**SUBJECT: COMANCHE PEAK NUCLEAR POWER PLANT, UNITS 3 AND 4
DOCKET NUMBERS 52-034 AND 52-035
COL APPLICATION PARTS 2, 4, AND 10 UPDATE TRACKING REPORTS**

COL Application Part 2, Final Safety Analysis Report Revision 1, Update Tracking Report Revision 0

**Comanche Peak Nuclear Power Plant, Units 3 & 4
COL Application**

Figure 8.1-1R Simplified One Line Diagram Electric Power System

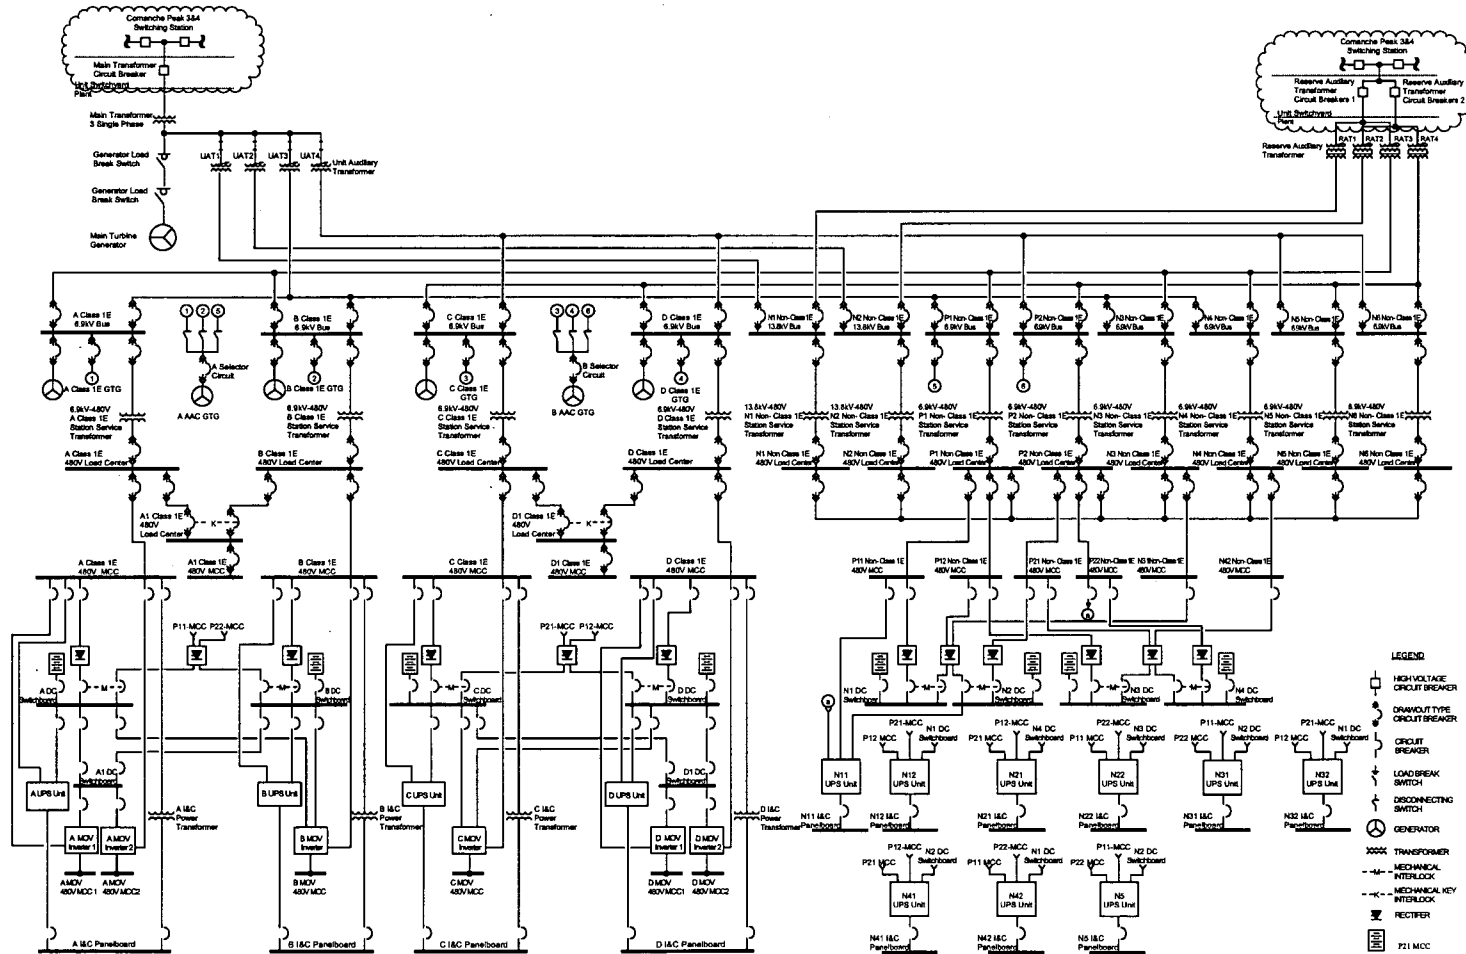
Change ID No.	Section	FSAR Rev. 1 Page	Reason for change	Change Summary	Rev. of FSAR T/R
MAP-08-201	Figure 8.1-1R	8.1-3	Consistency with DCD Revision 2	Deleted one feeder line between Class 1E LC and MCC, since two feeder lines were incorrectly depicted between Class 1E LC and MCC (editorial change). Added feeder lines from Class 1E MCC to MOV inverter. Changed the inputs to N21 and N22 UPS Units.	0

Figure 9.2.1-1R Essential Service Water System Piping and Instrumentation Diagram (Sheet 1 of 2)

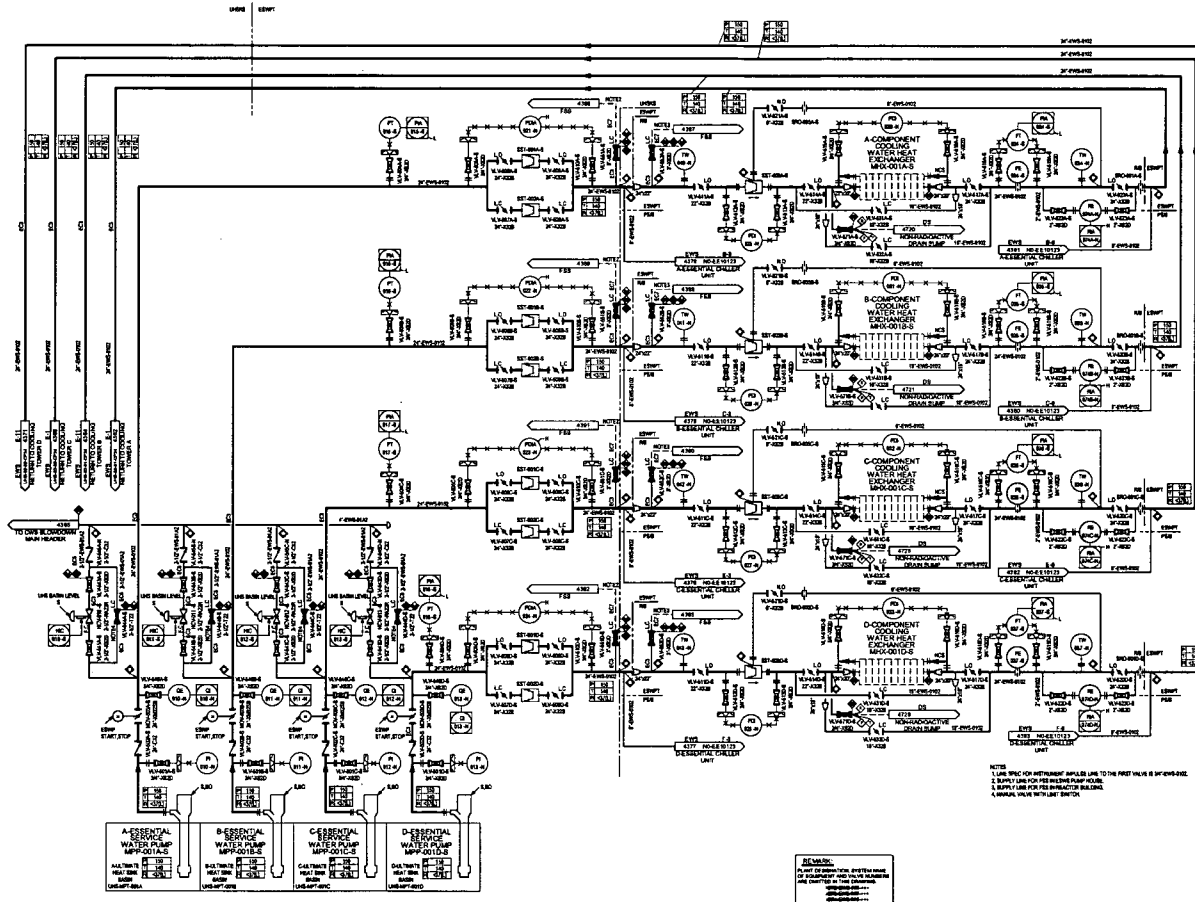
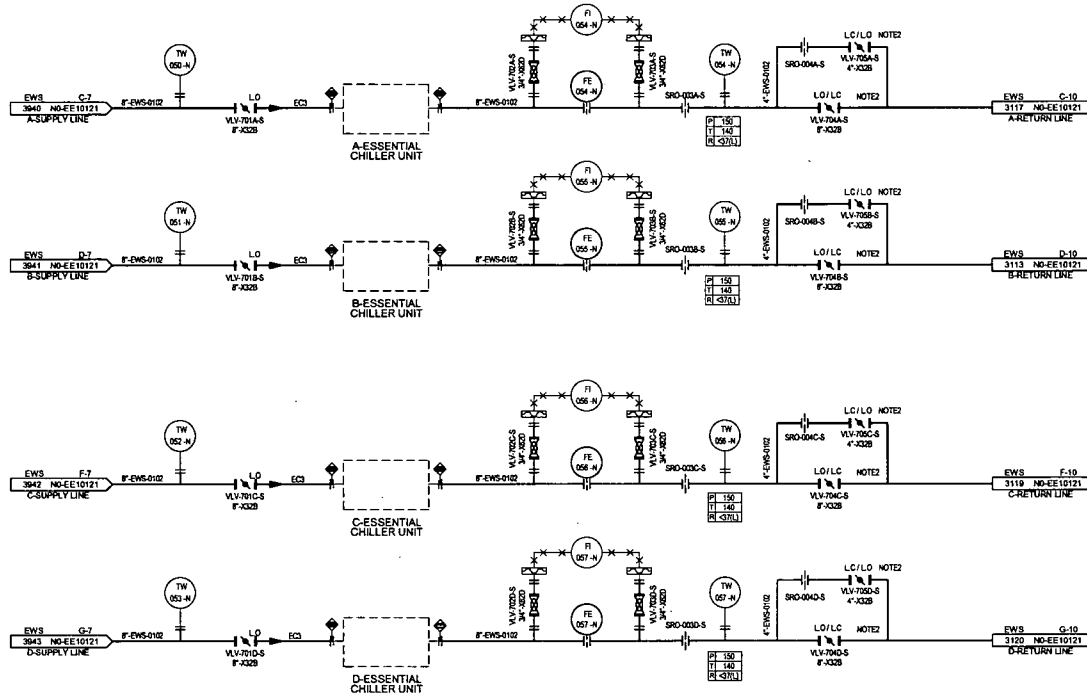
Change ID No.	Section	FSAR Rev. 1 Page	Reason for change	Change Summary	Rev. of FSAR T/R
RCOL2_09.04.05-10	Table 9.4-203 (sheets 1 thru 5)	9.4-12 Thru 9.4-16	Responses to RAI No. 123 Luminant Letter no. TXNB-09081 Dated 12/16/2009	Added Table 9.4-203 (Sheets 1 thru 5)	-
RCOL2_09.04.05-12	9.4.5.2.6	9.4-5	Responses to RAI No. 123 Luminant Letter no. TXNB-09081 Dated 12/16/2009	Revised seventh paragraph of Subsection 9.4.5.2.6 in conjunction with Change ID's RCOL2_09.04.05-09.	-
DCD_09.04.05-1	9.4.5.3.6 Table 9.4-203 (Sheet 1, 2 of 5)	9.4-4	Consistency with DCD	Change the sentence about the effect analysis of single active failure. And newly add Table 9.4-203 as FMEA.	0
MAP-00-201	Table 9.2.5-202 Figure 9.2.1-1R Figure 9.2.5-201 Figure 9.4-201	9.2-19 through 9.2-22 9.2-24 9.2-25 9.4-10	The change of numbering rule of Tag number	Change Tag numbers.	0

Figure 9.2.5-201 Ultimate Heat Sink System Piping and Instrumentation Diagram (Sheet 1 of 2)

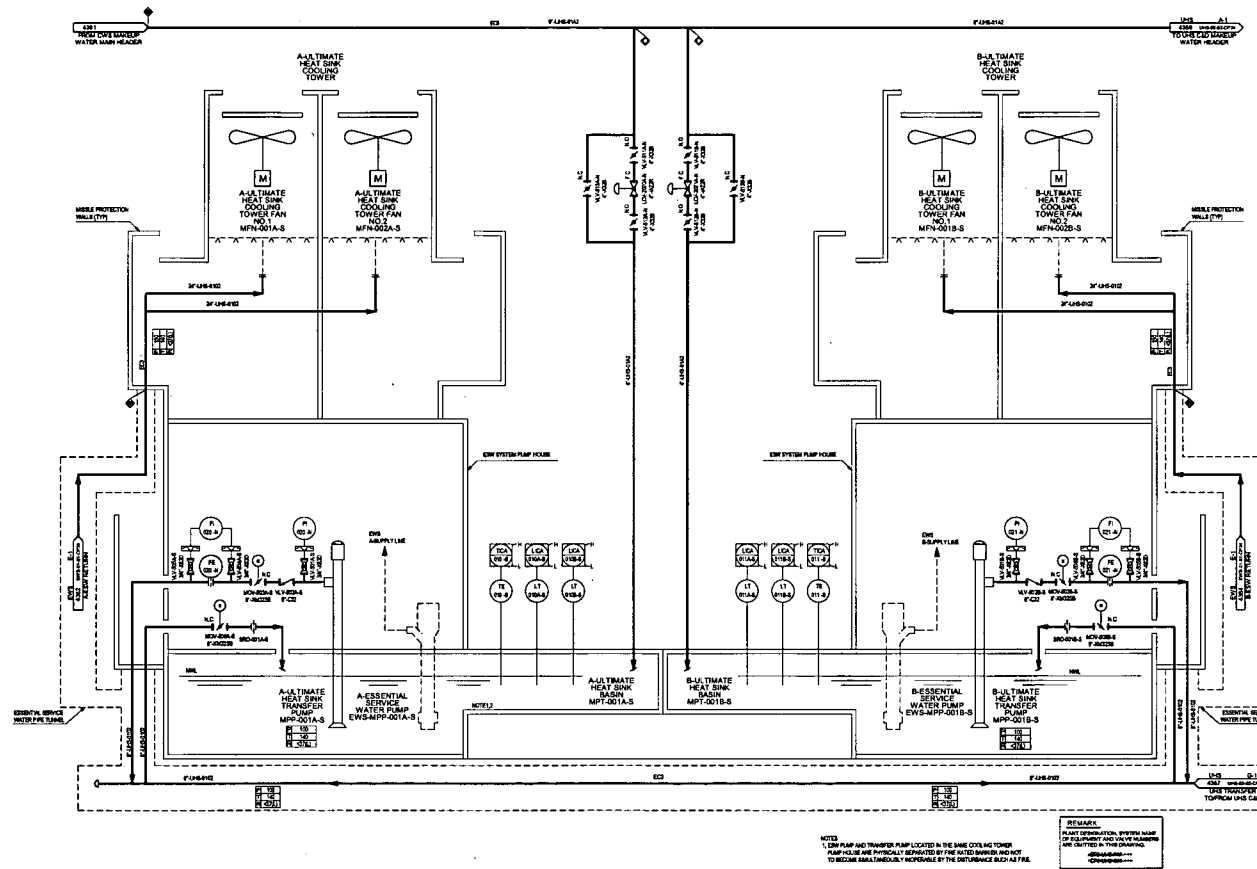
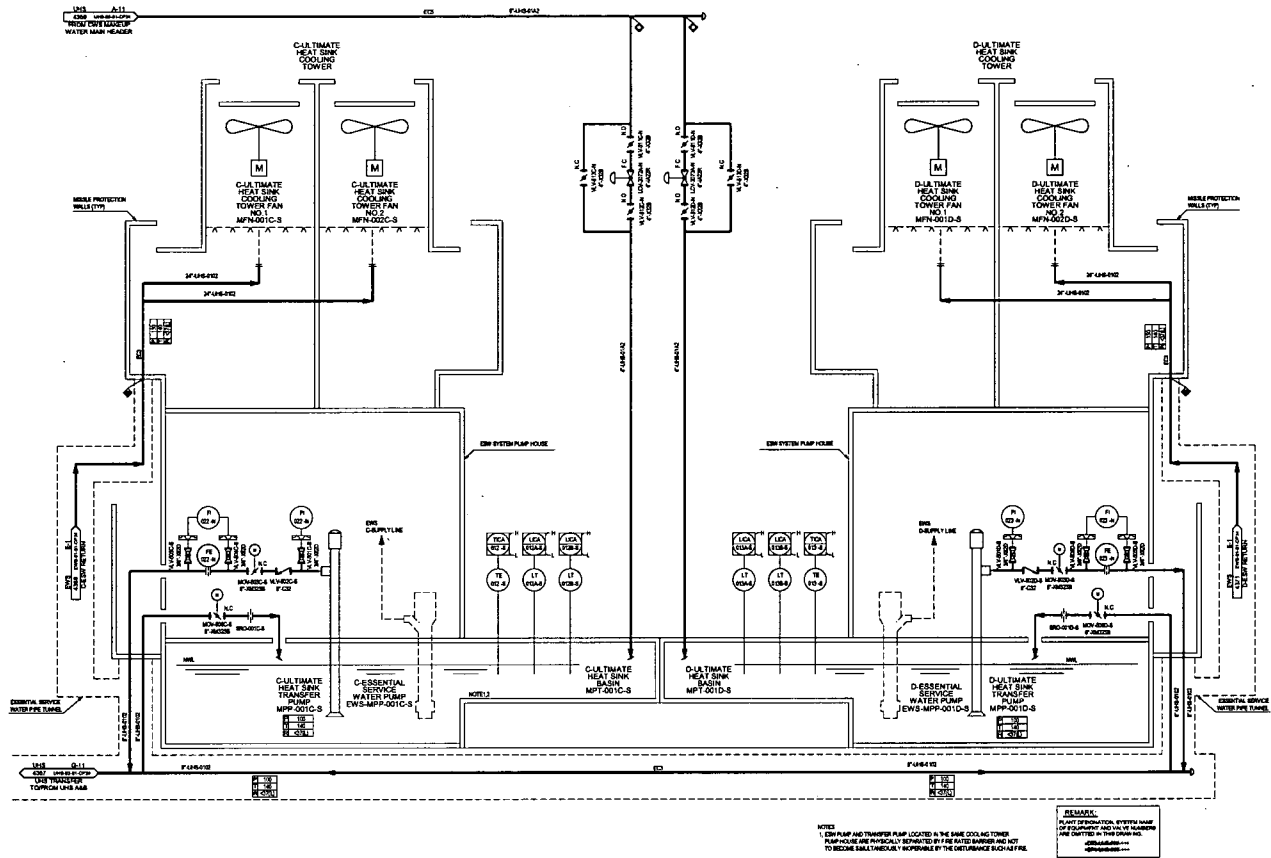
RCOL2_09.02.05-04	Figure 9.2.5-201 (sheets 1 and 2)	9.2-24 9.2-25	Responses to RAI No. 121 Luminant Letter no. TXNB-09081 Dated 12/16/2009	Added notes to Figure 9.2.5-201, Sheets 1 and 2.	-
RCOL2_09.02.05-05	9.2.5.2.1	9.2-8	Responses to RAI No. 121 Luminant Letter no. TXNB-09081 Dated 12/16/2009	Added fourth and fifth paragraphs to provide description for the cooling towers design conditions	-
RCOL2_09.02.05-05	9.2.5.2.3	9.2-12	Responses to RAI No. 121 Luminant Letter no. TXNB-09081 Dated 12/16/2009	Revised the last sentence of third paragraph to say recirculation penalty instead of margin.	-

Figure 11.2-201 Liquid Waste Management System Piping and Instrumentation Diagram (Sheet 9 of 10)

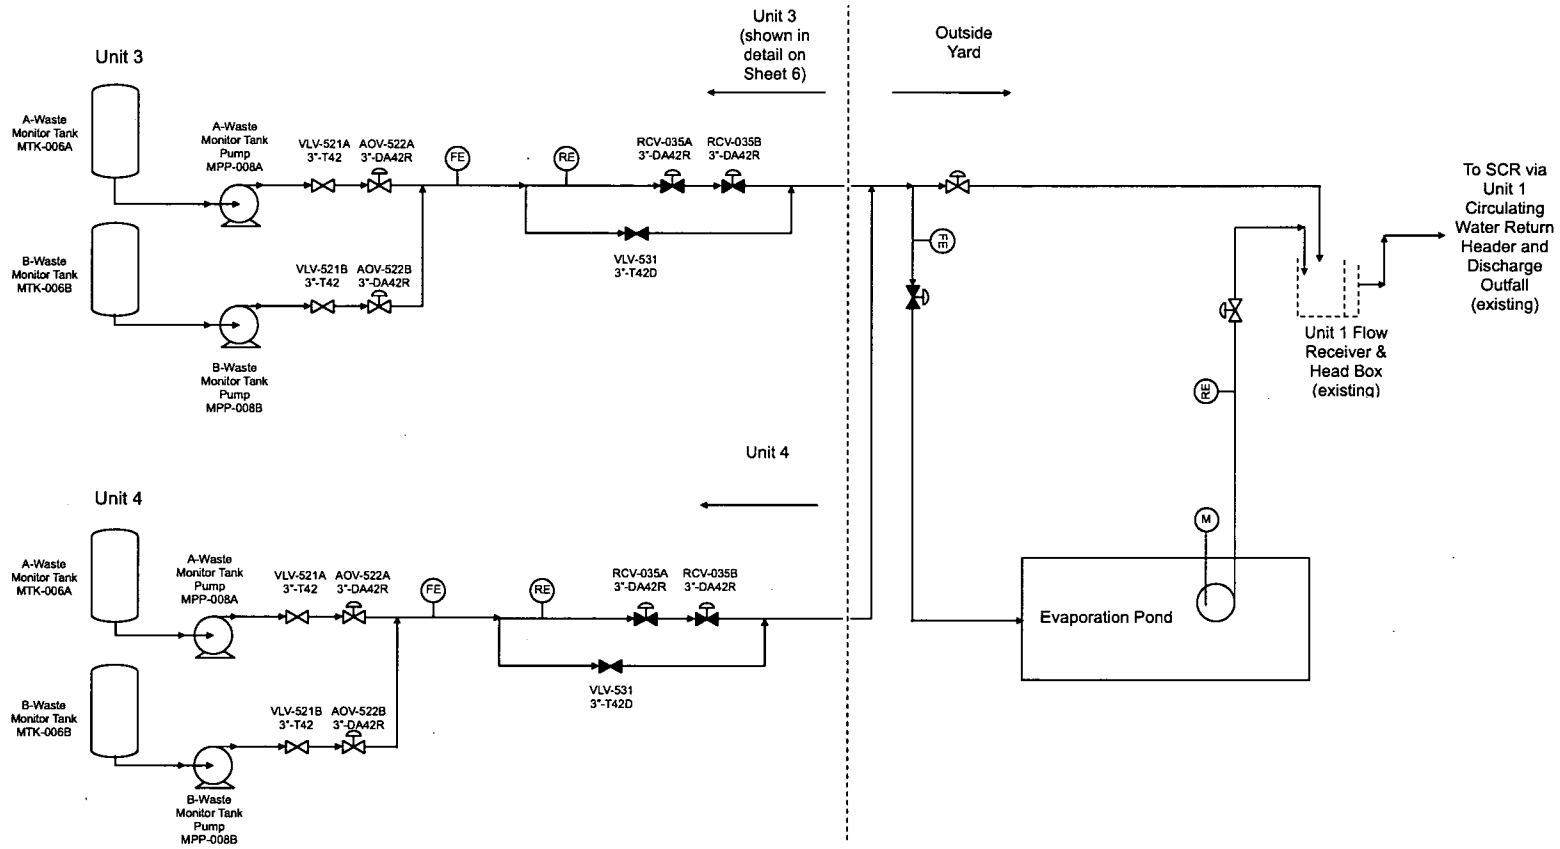
Change ID No.	Section	FSAR Rev. 0 Page	Reason for change	Change Summary	Rev. of FSAR T/R
MAP-11-201	11.5.2.9	11.5-2	Consistency with DCD rev.2	Add a sentence to be consistent with DCD Rev.2	0
MAP-00-201	Figure 11.2-201 (Sheet 9 of 10)	11.2-29	The change of numbering rule of Tag number	Change Tag numbers of waste monitor tank and pump.	0
